IREDELL COUNTY HEALTH DEPARTMENT

IMPROVEMENT PERMIT / AUTHORIZATION TO CONSTRUCT / OPERATION PERMIT / EXISTING SYSTEM INSPECTION

PERMIT# 10160[redacted] PIN# 4756-23-3974 DATE 7-18-01

SUBDIVISION BRAINTWOOD BLOCK / SECTION _____ LOT 3 LOT AREA .59 AC SITE CLASS PS DESIGN FLOW 360 L.T.A.R. .3

AS BUILT SKETCH

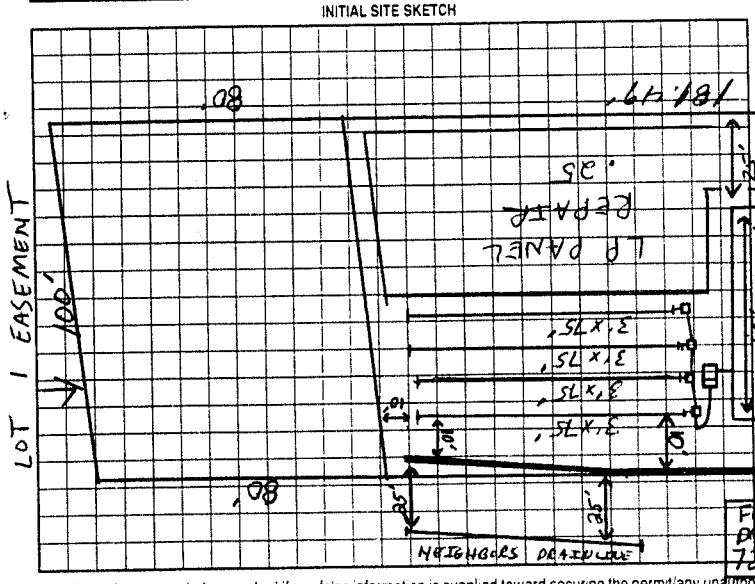
TOLD ON 11-26-01, BEFORE SLAB WAS POURED, THAT STUBOUT WAS IN WRONG PLACE & MAY HAVE TO BE CHANGED TO PUMP! LC

IF DITCH IS DEEPER THAN 36" FIRST TWO LINES CHECKED & FRENCH DRAIN CHECKED POLYLOK FILTER 12-5-01

(X) EVERYTHING CHECKED OUT SUMP PUMP - NEED TO SEE ELECTRICAL RECEPTACLE (GFI ISSUE OK) FOR SUMP IN JUNCTION HOUSE & SEE PUMP WORK LC 12-5-01

Comments/Conditions: (1) INSTALL FRENCH DRAIN 25' BELOW NEIGHBORS SYSTEM, 10' ABOVE NEW SYSTEM & HAVE FALL TO THE ROAD. (2) INSTALL SUMP PUMP & BASIN AS CLOSE TO FRONT PROPERTY LINE AS POSSIBLE & HAVE OUTLET IN DITCH.

Comments/Conditions: (3) MAINTAIN SETBACKS (4) PERMIT CAN NOT BE SIGNED OFF UNTIL NEEDED TRAIT EASEMENT FOR LOT 1 HAS BEEN COMPLETED POLYLOK FILTER & MARKER
